Mobile Intel® Celeron® Processor on .13 Micron Process in Micro-FCPGA Package

Specification Update

March 2004

Document Number: 251309-018

Figure 12. System Bus Reset and Configuration Timings

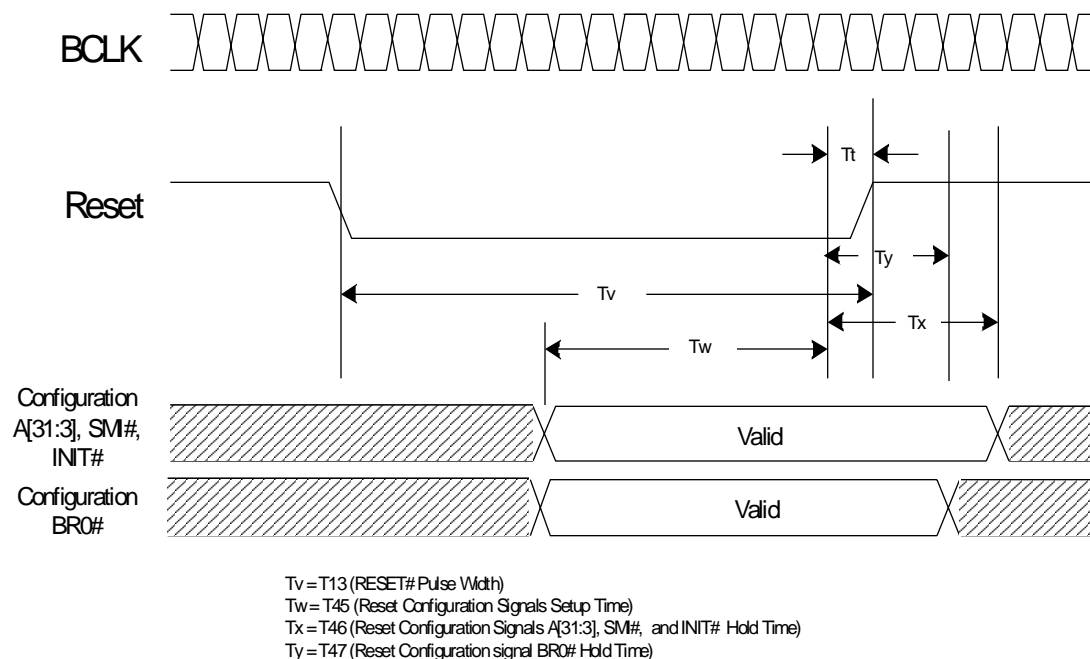
V2. BR0# Maximum Hold Time Specification Change

The BR0# maximum hold time has changed to 2 BCLKs. This change will be shown in the “System Bus AC Specifications (Reset Conditions)” table and “System Bus Reset and Configuration Timings” figure of the *Mobile Intel® Celeron® Processor on .13 Micron Process in Micro-FCPGA Package Datasheet*. This change will be incorporated in the next revision of the datasheet.

The following figure will be modified to reflect this change:

T# Parameter	Min	Max	Unit	Figure	Notes
T45: Reset Configuration Signals (A[31:3]#, BR0# INIT#, SM#) Setup Time	4		BCLKs	13	1
T46: Reset Configuration Signals (A[31:3]#, INIT#, SM#) Hold Time	2	20	BCLKs	13	2
T47: Reset Configuration Signal BR0# Hold Time	2	2	BCLKs	13	2
